Access Compliance Report

Public Rights-of-Way

Intersection ID: 28255	Main Street: REA_RD	Cross Street: ARDREY_KELL_RD	Location: SE
ADA ID: 610F12054E93	Ramp Type: BlendTrans1	Initial Pass/Fail: Fail	Overall Compliance: No
Codes/Mitigation Info/Possible Solution			Severity Score: 10
			Field Measurements/Component Compliance

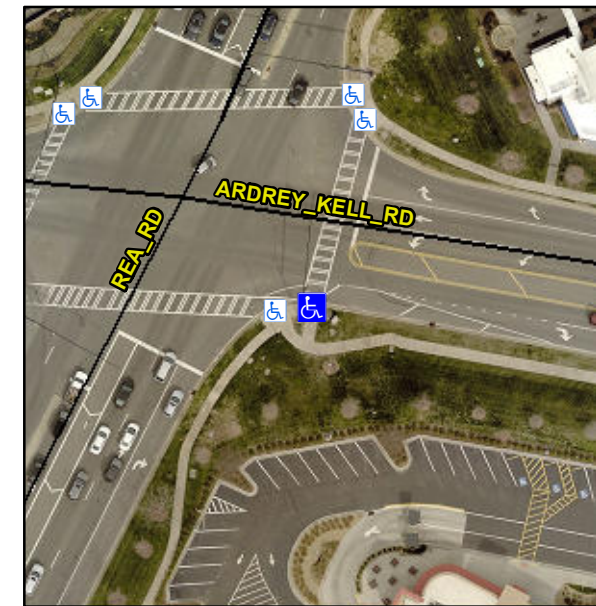
R304.5.1

Compliance	Description	Data	Compliance	Description	Data
N/A	Ramp Length (in)	74.0	Yes	BlendTrans Slope (%)	3.8
No	Ramp Width (in)	45.0	Yes	BlendTrans XSlope (%)	2.8
N/A	Flare Type LT	N/A	N/A	Flare Type RT	N/A
N/A	Flare Slope LT (%)	N/A	N/A	Flare Slope RT (%)	N/A
N/A	Flare Traversable LT?	N/A	N/A	Flare Traversable RT?	N/A
N/A	Landing Length (in)	N/A	N/A	DWS Provided?	N/A
N/A	Landing Width (in)	N/A	N/A	DWS Contrast?	N/A
N/A	Landing Slope (%)	N/A	N/A	DWS Length (in)	N/A
N/A	Landing X Slope (%)	N/A	N/A	DWS Full Width?	N/A
N/A	Landing Curb? (Y/N)	N/A	N/A	DWS Offset (in)	N/A
N/A	Shared Landing?	N/A			
N/A	Gutter Ponding?	N/A	N/A	Gutter Slope (%)	N/A
N/A	Gutter Lip Ht (in)	N/A	N/A	Gutter X Slope (%)	N/A
N/A	Painted X Walk1?	Yes	N/A	Painted X Walk2?	N/A
	X Walk 1 Direction	To NE		X Walk 2 Direction	N/A
	X Walk 1 Width (in)	112.0		X Walk 2 Width (in)	N/A
	X Walk 1 Slope (%)	1.1		X Walk 2 Slope (%)	N/A
	X Walk 1 X Slope (%)	3.4		X Walk 2 X Slope (%)	N/A

Remove & Replace Curb Ramp With Two New Directional Ramps or Equivalent.
